AGENDA
Regular Hybrid Meeting
Town of Granby
Inland Wetlands and Watercourses Commission
Wednesday, April 9, 2025, at 7:00 pm
Town Hall Meeting Room

MEETING MINUTES
Town of Granby
Inland Wetlands and Watercourses Commission
Wednesday, March 12, 2025, at 7:00 pm

RE: 188 Day Street Plans

Re: Review of March 28, 2025 Brook Crossing Plan and Alternatives Analysis Statement
15 Peck Orchard Road, Granby, CT
JE Project No. 21-29

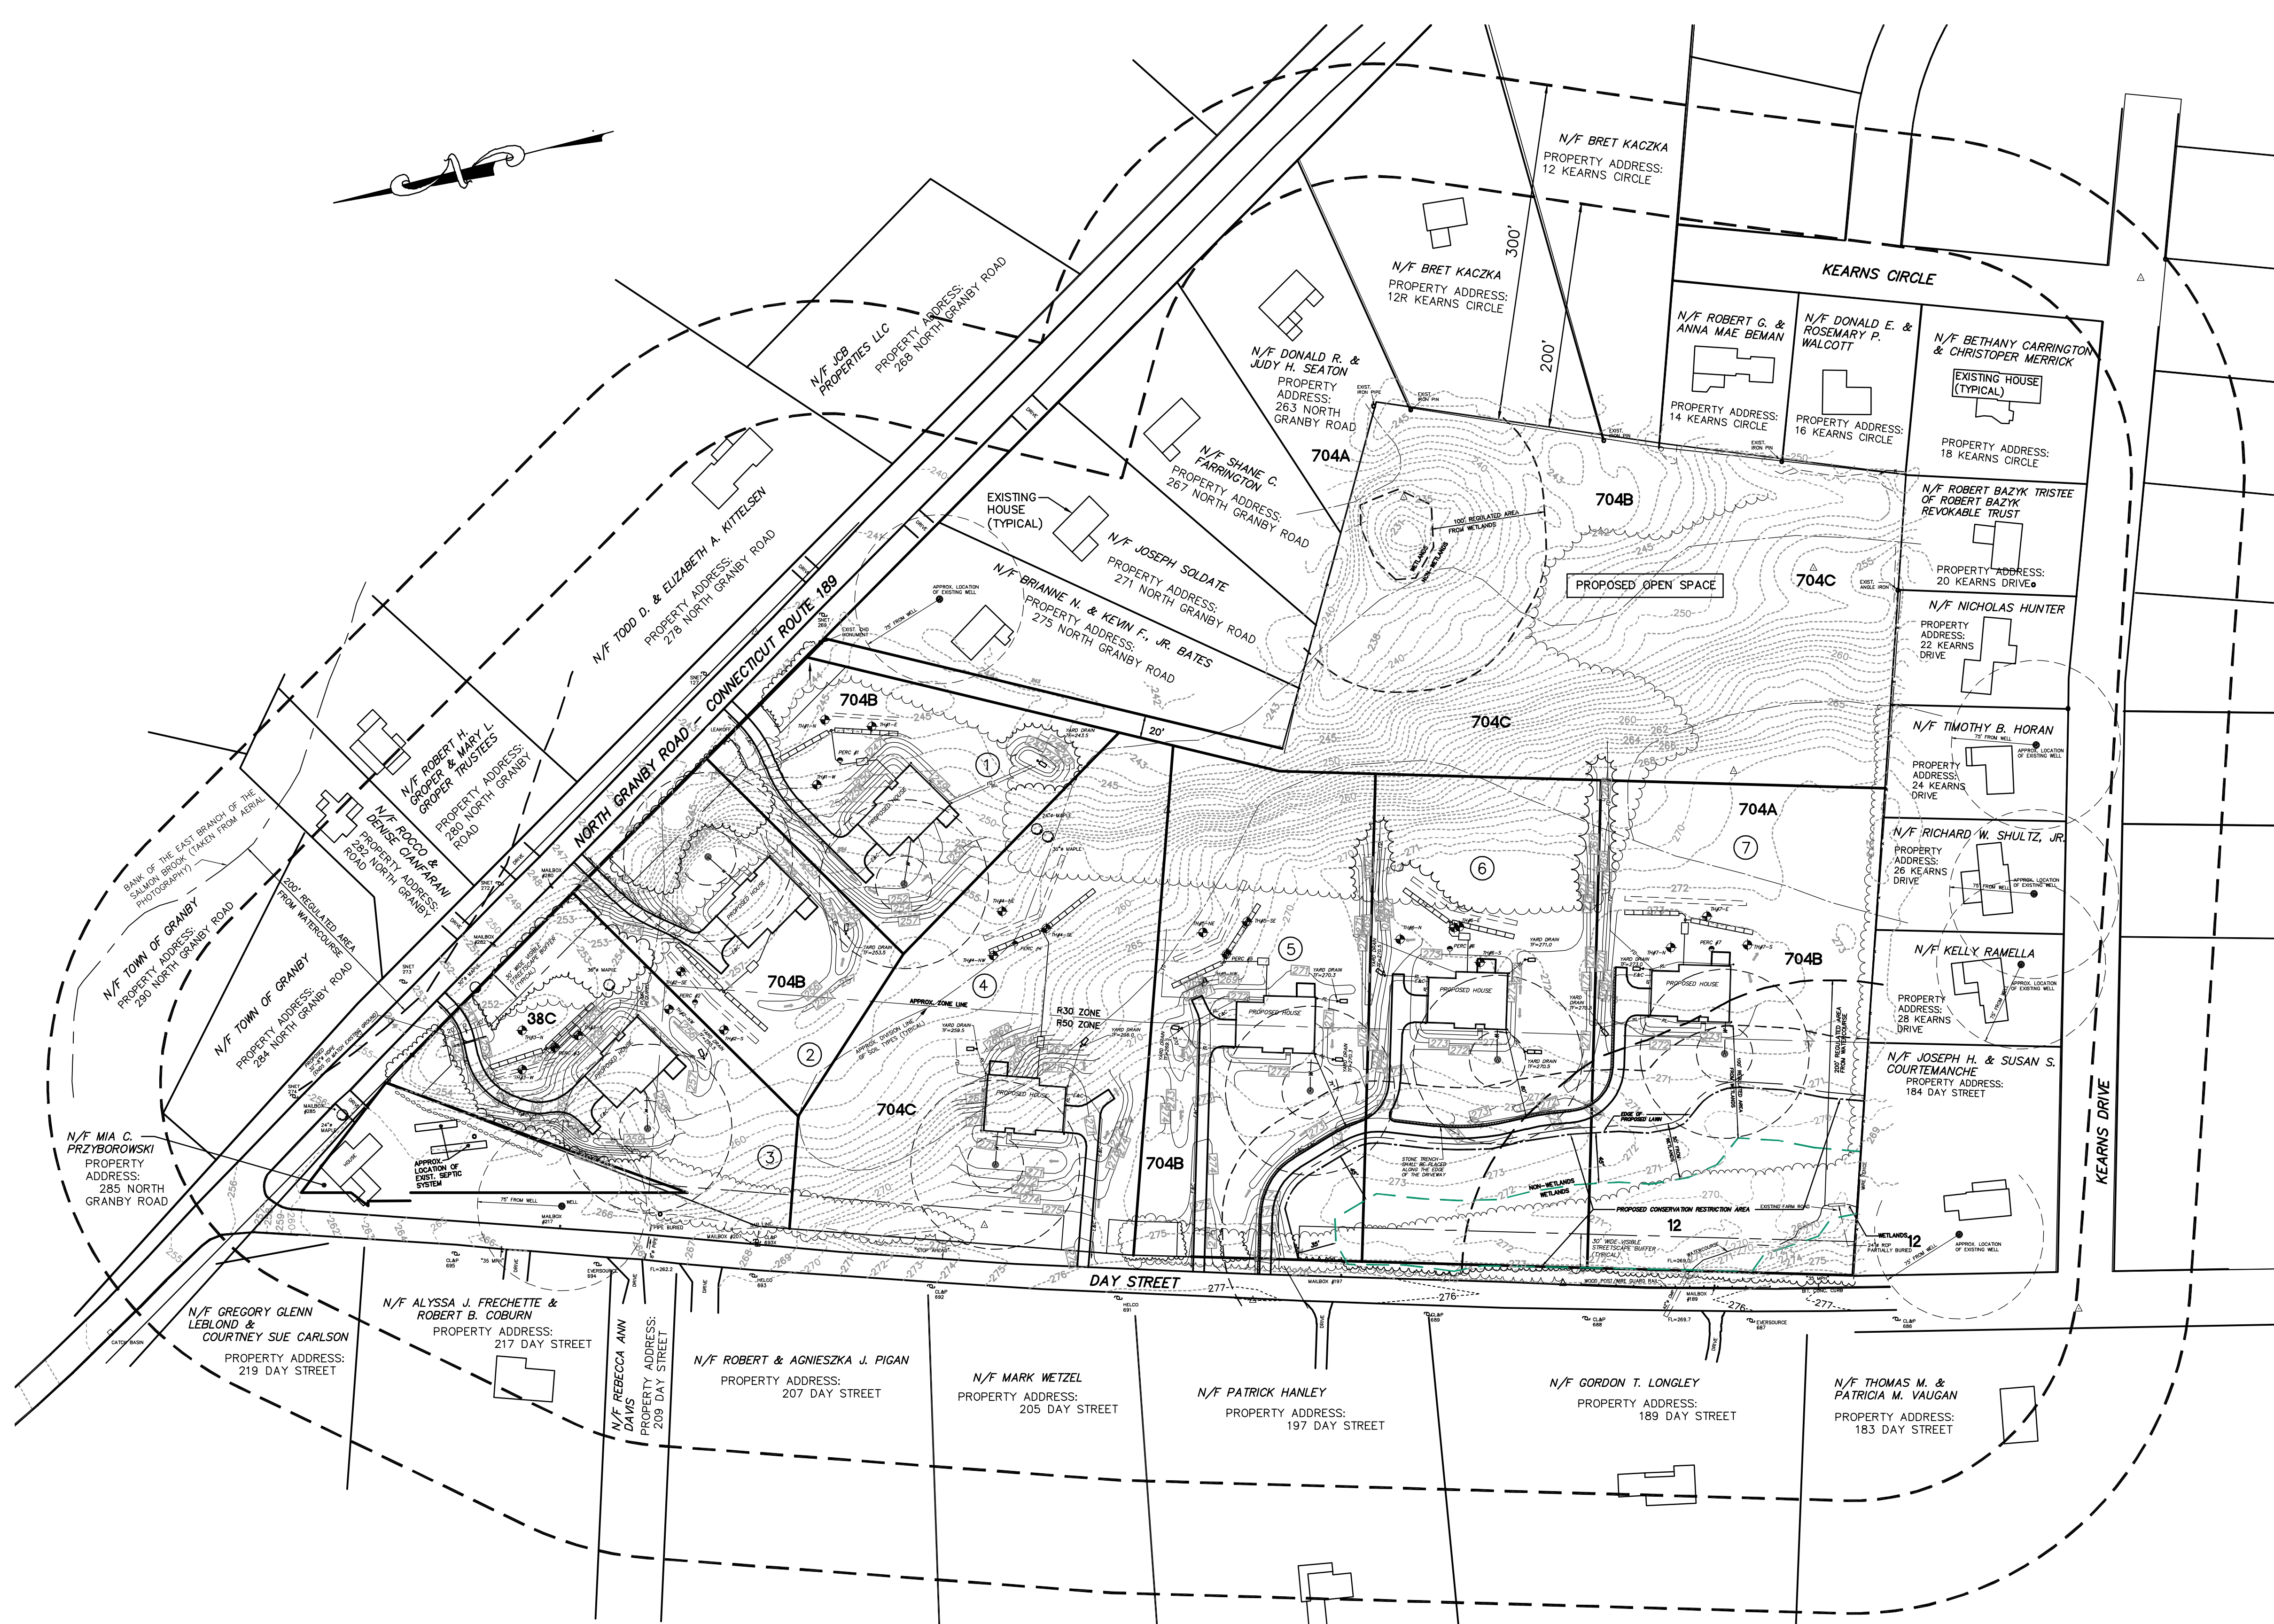
Comment 1 The total amount of the disturbed area is a required part of the erosion and sediment control narrative and should be on the plan.

Comments 2-6 The property lines shown are not clear and there is no technical information while the plan is certified as an A-2 survey. If is not an A-2 survey, then that certification should be removed. Because any decision by the Wetlands Commission applies to the property, then the property lines must be clearly shown and any discrepancies removed or clarified.

Comment 8 Drainage easement not shown. As this is within the regulated area it should be shown.

Comment 11 The flooding limit should be shown on the design plans and ultimately the subdivision plan.

Attached are the revised plan Kirk submitted this morning. I told Kirk I would pass them on to you for review. He is copied on this email.

BROOK CROSSING PLAN
15 Peck Orchard Road
Granby, Connecticut
Granby Inland Wetlands and Watercourses Commission
Inland Wetlands Permit Application
February 18, 2025
(Revised to March 28, 2025)

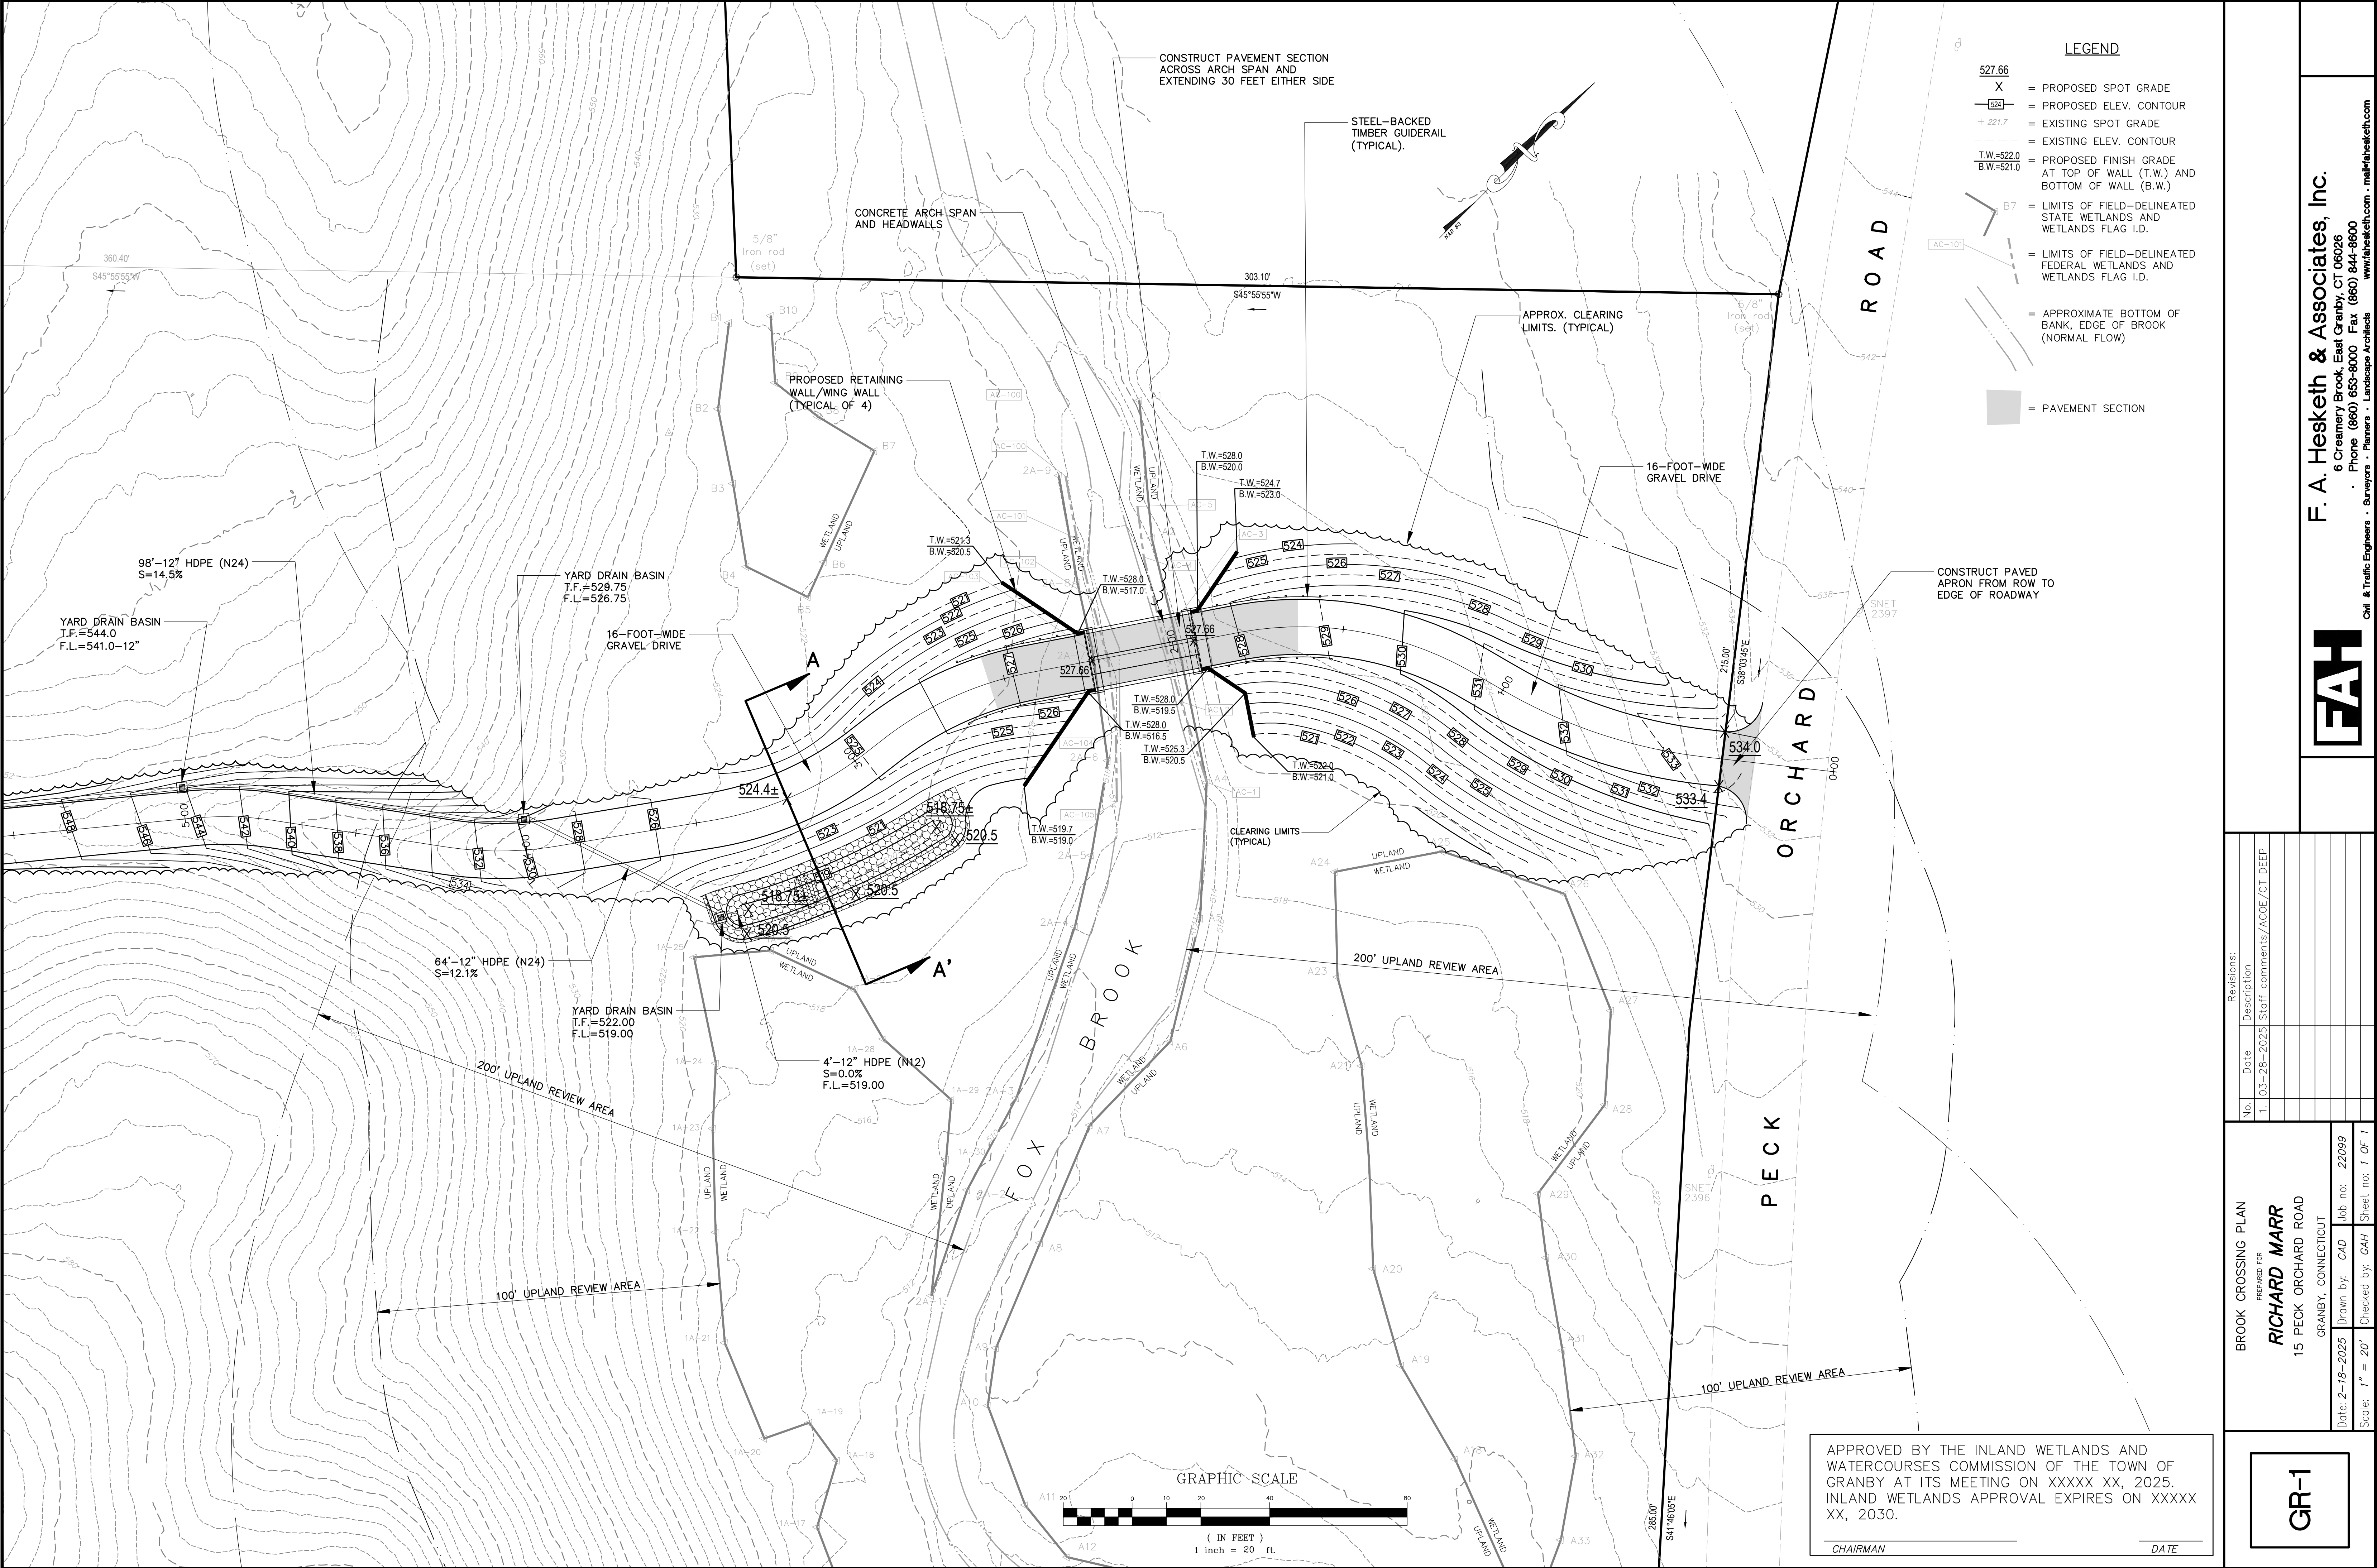
The proposed Soil Erosion and Sediment Controls, shown on Plan Sheets EC-1 and EC-2, and the General Erosion and Sediment Control Notes and Erosion Control Devices (Sheet NT-1) are adequate and conform with protocols contained in the 2024 Connecticut Guidelines for Soil Erosion and Sediment Control.¹ The proposed Soil Erosion and Sediment Controls within the Brook Crossing Plan are protective of the inland wetlands and the Fox Brook watercourse shown in the Crossing Plan.
